**HISTORIC AND DESIGN REVIEW COMMISSION
COMPLIANCE AND TECHNICAL ADVISORY BOARD**

HDRC CASE NO:	2025-134
ADDRESS:	617 E GUENTHER ST
LEGAL DESCRIPTION:	NCB 940 BLK 3 LOT 7&8
ZONING:	RM-4, H
CITY COUNCIL DIST.:	1
DISTRICT:	King William Historic District
APPLICANT:	Jorgeluis Espinoza/Blue Hammer Construction LLC
OWNER:	EM INVESTMENT GROUP LLC & THREE OAKS REALTY LLC
TYPE OF WORK:	Wood window replacement
APPLICATION RECEIVED:	May 08, 2025
60-DAY REVIEW:	July 07, 2025
CASE MANAGER:	Bryan Morales

REQUEST:

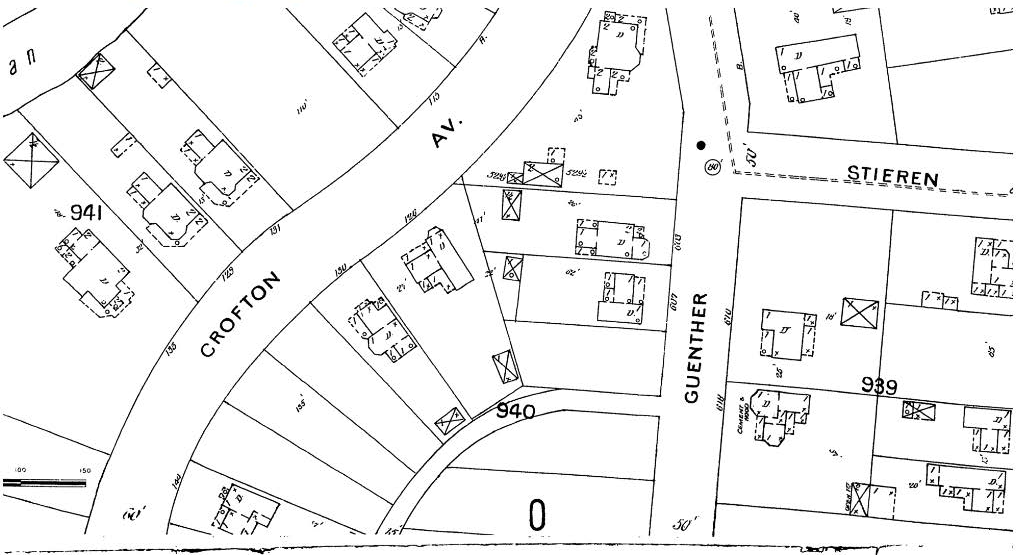
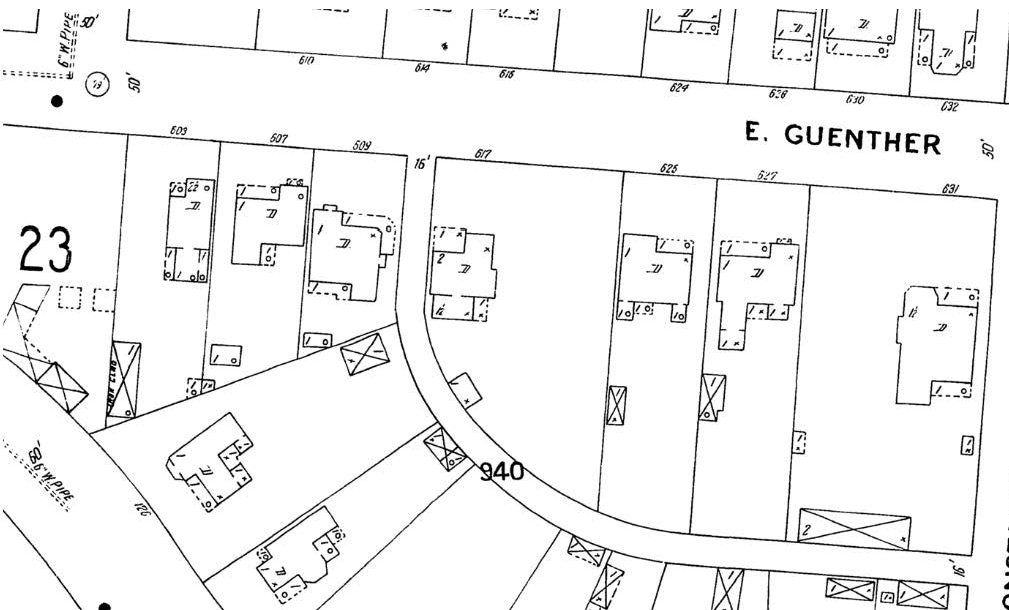
- b. WINDOW REPLACEMENT: EXISTING CONDITION – Staff conducted a site visit on June 12, 2025, to assess the existing window condition and found that the first-floor's two-over-two wood window proposed for replacement is a good candidate for in-kind repair. The two one-over-one wood windows located on the second floor are missing their bottom halves and are eligible for replacement with an in-kind window product meeting staff's standard stipulation. Staff does not recommend replacement of the first-floor window. Staff may administratively approve replacement of the two one-over-one wood windows on the second floor provided the applicant replaces the

windows in-kind. Staff finds the replacement of three wood windows onsite with an aluminum window product to match previously replaced windows does not conform to Guidelines.

Staff does not recommend approval of the request, based on the findings. Staff recommends the applicant repair the first-floor wood window in-kind and replace the two one-over-one wood windows on the second floor with a salvaged wood window or a new fully wood window conforming to Guidelines.
